**Comanche Peak Nuclear Power Plant, Units 3 & 4
COL Application**

FSAR Revision1

Update Tracking Report

Revision 8

Figure 9.2.5-2041R Ultimate Heat Sink System Piping and Instrumentation Diagram (Sheet 1 of 2)

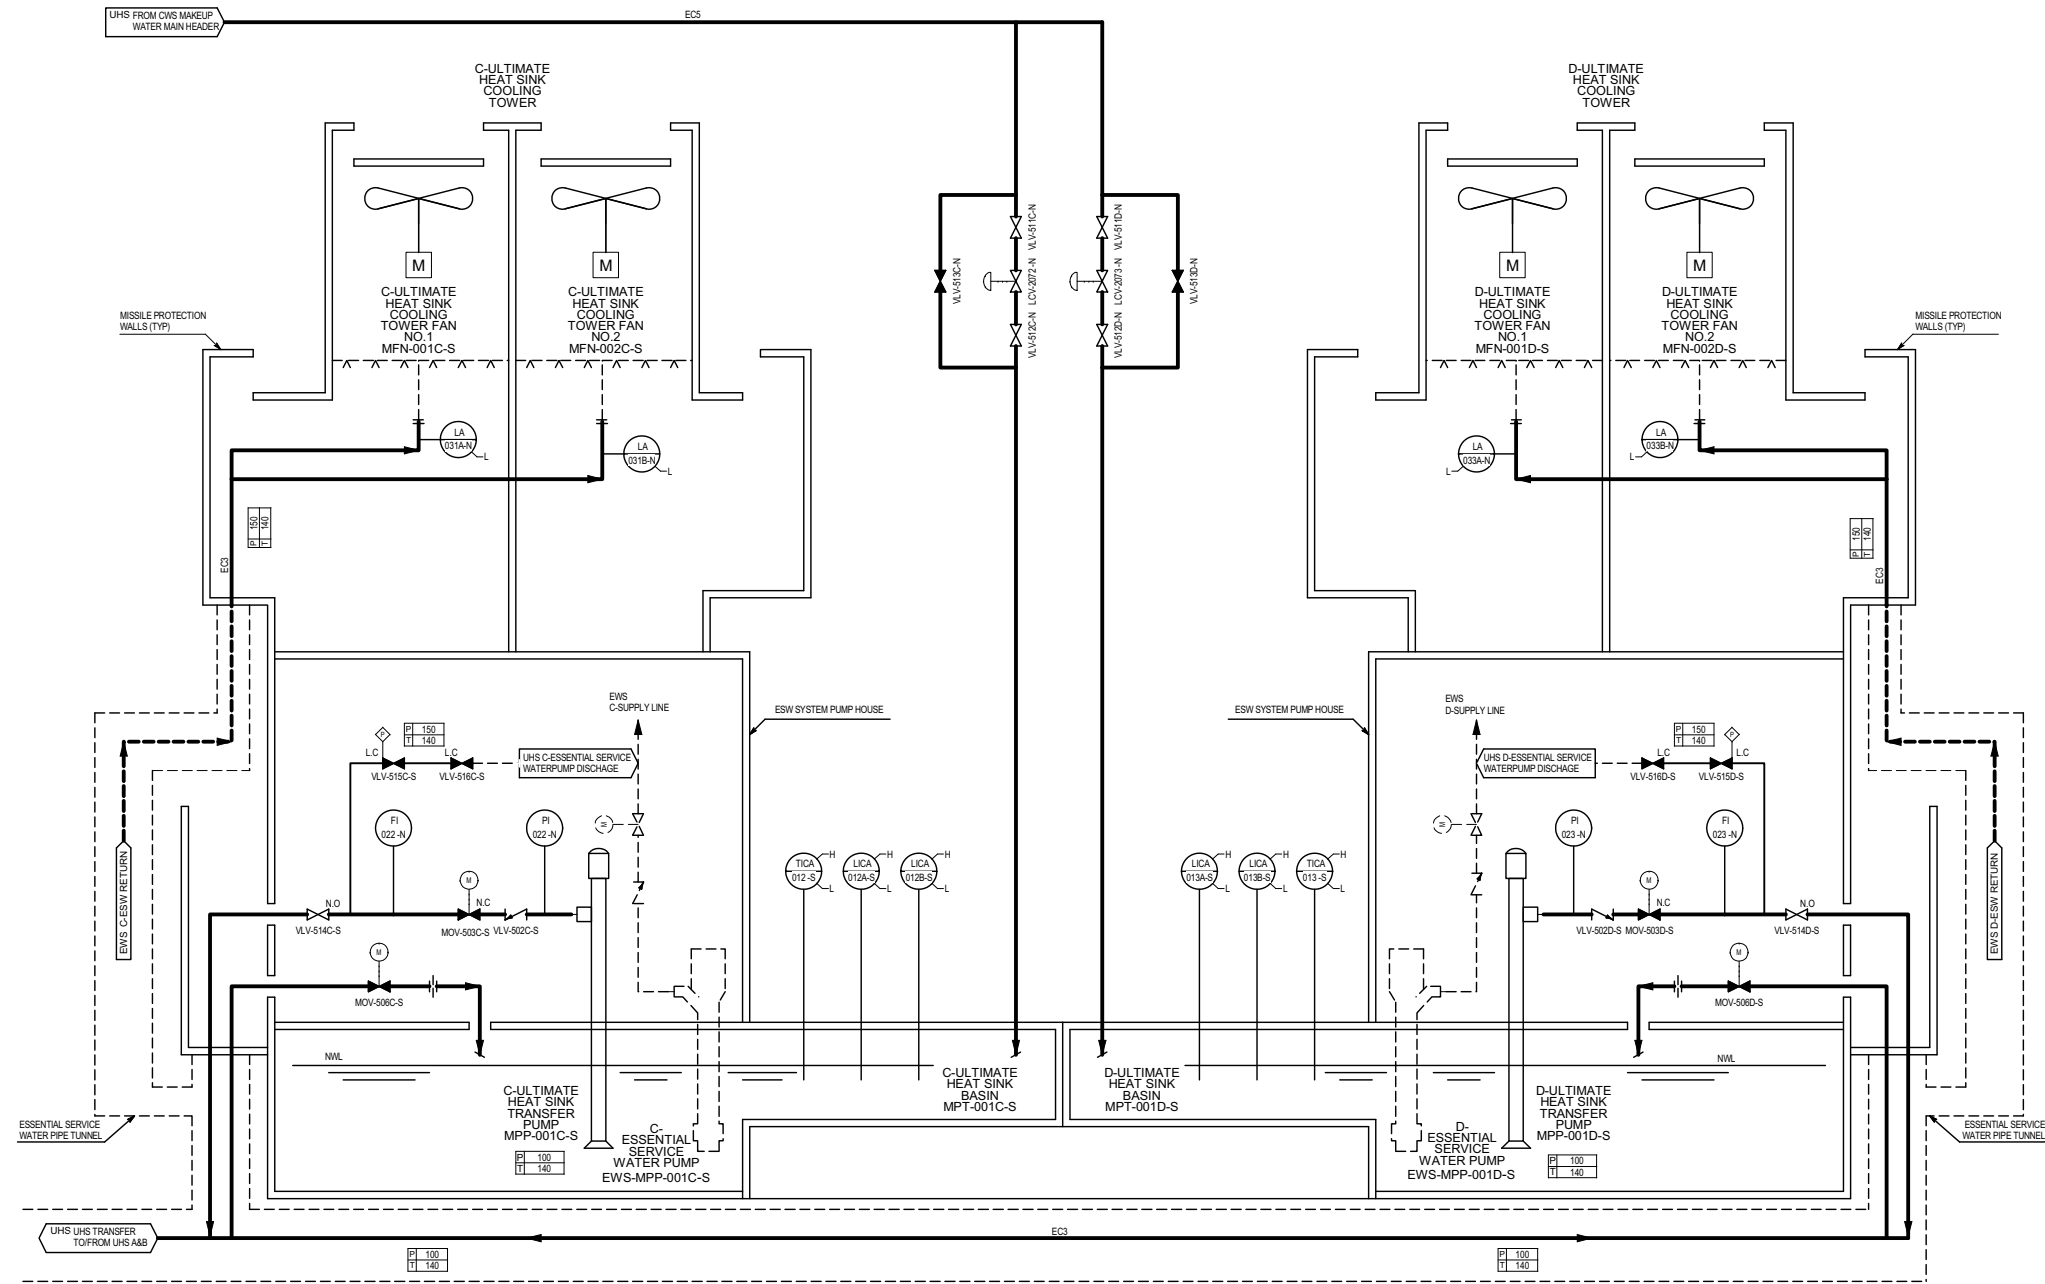
Change ID No.	Section	FSAR Rev. 1 Page*	Reason for change	Change Summary	Rev. of FSA R T/R
MAP-00-201	Table 9.2.5-202 Figure 9.2.1-1R Figure 9.2.5-201 Figure 9.4-201	9.2-19 through 9.2-22 9.2-24 9.2-25 9.4-10	The change of numbering rule of Tag number	Change Tag numbers.	0
RCOL2_09.02.0 4-02	9.2.4.1	9.2-4	Response to RAI No. 126 Luminant Letter no. TXNB-10008 Date 2/18/2010	Deleted first bullet.	-
RCOL2_09.02.0 4-02	9.2.4.2	9.2-5	Response to RAI No. 126 Luminant Letter no. TXNB-10008 Date 2/18/2010	Added Subsection 9.2.4.2. CP COL 9.2(11)	-
RCOL2_09.02.0 4-02	9.2.4.2.1	9.2-5	Response to RAI No. 126 Luminant Letter no. TXNB-10008 Date 2/18/2010	Revised second paragraph to clarify that the PSWS does not share between any radiological controlled systems.	-
RCOL2_09.02.0 4-03	9.2.4.2.2.4	9.2-6	Response to RAI No. 126 Luminant Letter no. TXNB-10008 Date 2/18/2010	Added Subsection 9.2.4.2.2.4. CP COL 9.2(13)	-

Figure 9.5.1-201 Fire Protection Water Supply System (Sheet 2 of 2)

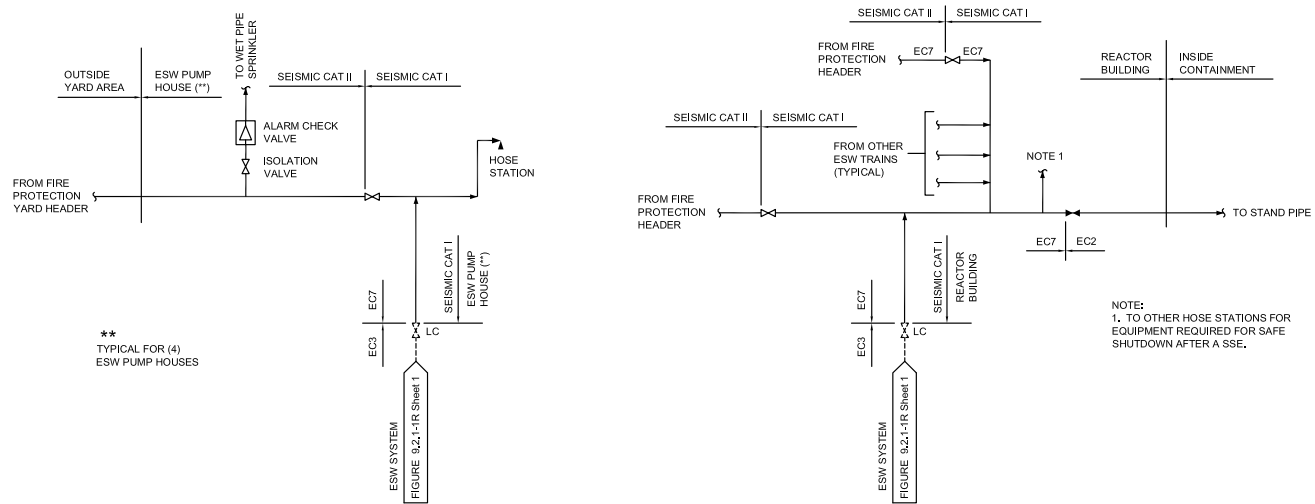
Change ID No.	Section	FSAR Rev. 1 Page*	Reason for change	Change Summary	Rev. of FSA R T/R
			Letter no. TXNB-10007 Date 2/19/2010		
RCOL2_09.02.0 1-5 S01	Figure 9.2.1-1R	9.2-26	Response to RAI No. 109 Supplemental Luminant Letter No. TXNB-10011 Date 2/22/10	Revised figure to reference Figure 9.5.1- 201.	-
RCOL2_09.02.0 1-5 S01	Figure 9.5.1-201 (Sheet 1 of 2)	9.5-148	Response to RAI No. 109 Supplemental Luminant Letter No. TXNB-10011 Date 2/22/10	Added "Sheet 1 of 2" to Figure 9.5.1-201.	-
RCOL2_09.02.0 1-5 S01	Figure 9.5.1-201 (Sheet 2 of 2)	9.5-149	Response to RAI No. 109 Supplemental Luminant Letter No. TXNB-10011 Date 2/22/10	Added second sheet to Figure 9.5.1-201.	-
RAI GEN-09	Figure 9.2.4-2R (Sheet 2 of 2)	9.2-29	Response to RAI GEN-09 Luminant Letter No. TXNB-10013 Date 2/24/2010	Added new figure to FSAR Ch 9 to supplement Figure 9.2.4-1R, this figure was not added correctly and the name will be changed to 9.2.4-201 in the next UTR, in addition Luminant requests that the title be changed to "Sanitary Water System Flow Diagram" and "sheet 2 of 2" will be removed	-
